**Partial External Facade
Building Survey Report**

Levels G.F – Lower Penthouse (& two private lots)

ABC Apartments
Strata Plan No 70XXX

Prepared By
Access Property Services Pty Ltd

Photo No14

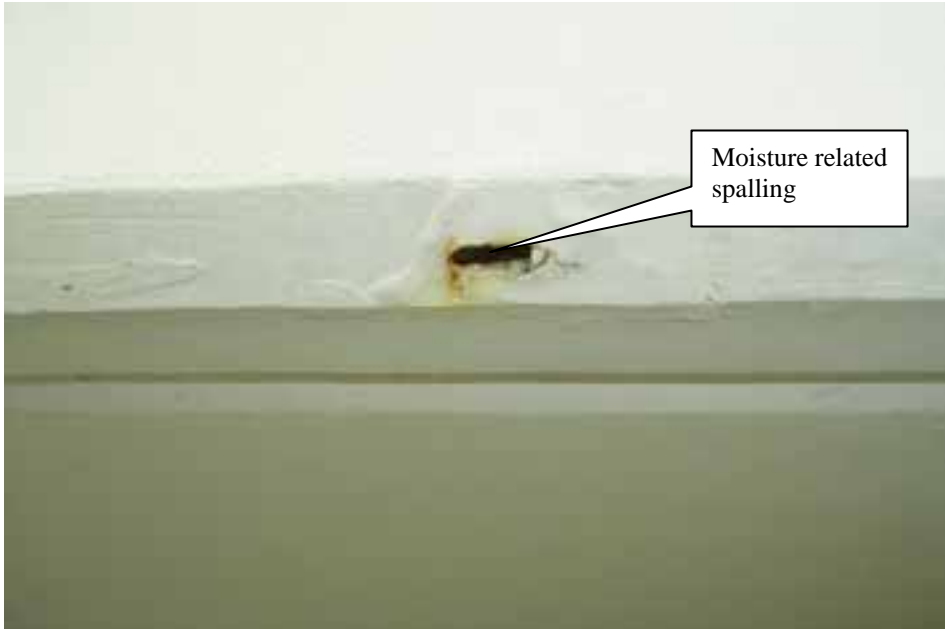
Very significant *rust staining and evidence of moisture seepage (at base)* of the seemingly *steel stud, fibre cement clad* service pipe enclosure at the southern end of this balcony – *Refer Photo No13 & 14* and which is fixed to a masonry wall

In my professional opinion such significant rusting and lower wall seepage, in this location, is likely to be caused either due to a failure in the protective paint film above, and/ or due to an inadequate waterproof detail (to accommodate differential movement) between the steel stud wall and masonry wall. The resultant rusting has occurred due to the presence of metal external setting edges been used when setting the fibre cement sheets.

If the balcony waterproof membrane has not been carried through beneath this stud framed enclosure, then the noted seepage would be gaining entry into the balcony slab.

I **recommend** that the front F.C panel of stud framed service enclosure be removed and that the presence of a waterproof membrane, on the balcony slab directly beneath, is verified.

I **recommend** that the junction of the steel stud enclosure and masonry wall incorporate an adequate waterproof expansion joint (including breaker bond) which accommodates differential movement and that all metal external angles and rusted screw fixings be removed and replaced with a rust resistant type (e.g. plastic external angles).

Photo No20

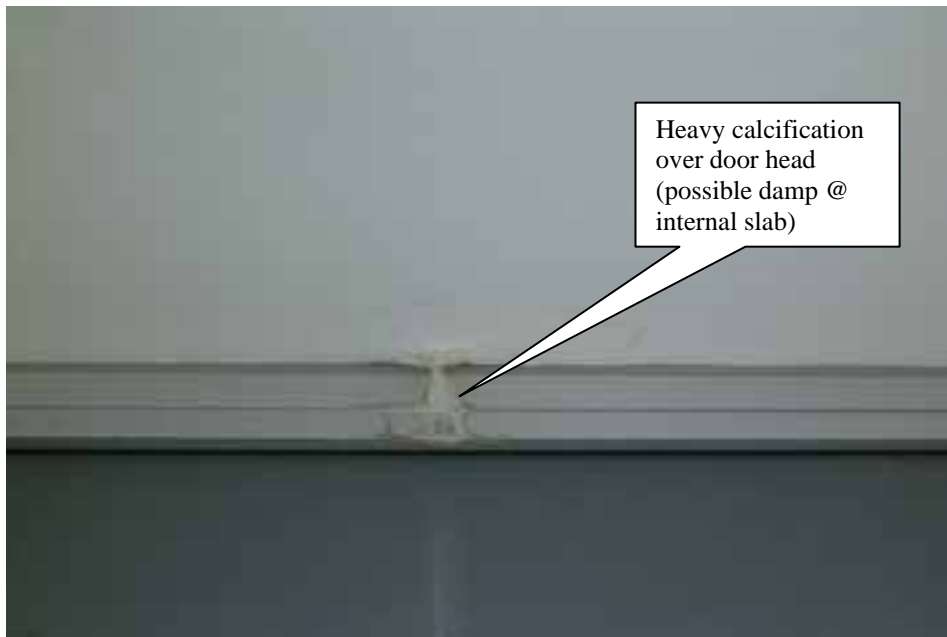
Severe evidence of *moisture related paint film bubbling, staining delamination and calcification* on the sub penthouse balcony rearward slab *soffit*, at three locations along its length, in near proximity to F.C clad columns *Refer Photos No20, 21 & 22.*

In my professional opinion this moisture related paint film damage and calcification has occurred due to the presence of *very high moisture content within the balcony slab* and which is entrapped by the exterior coating.

The noted calcification (lime leaching) is heavy and in my opinion has occurred because of long-term saturation of the slab.

I **recommend** that all the moisture damaged exterior coating on the sub Penthouse balcony soffit/s be thoroughly stripped back and the slab allowed to dry.

I **recommend** that all causes of moisture entry into the building fabric and F.C clad columns be rectified and that all damp substrates be allowed to thoroughly dry out prior to the re-application of a protective paint waterproof paint. Refer also later recommendations for balcony balustrade rebates and at junction of balcony slab soffits \ walls \ columns.
